REMARKS

Reconsideration of the above-identified application in view of the following remarks is respectfully requested.

Fig. 5

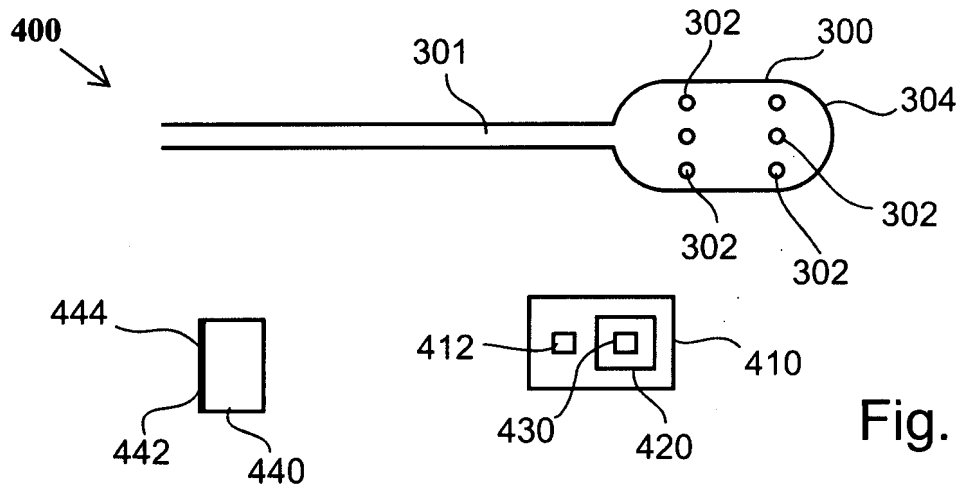
The Examiner has objected to the drawings as failing to comply with 37 CFR 1.84(p)(5) because they do not include reference signs for "System 400" mentioned in the description. A reference sign for System 400 has been added to Figure 5, a corrected copy of which is submitted herewith.
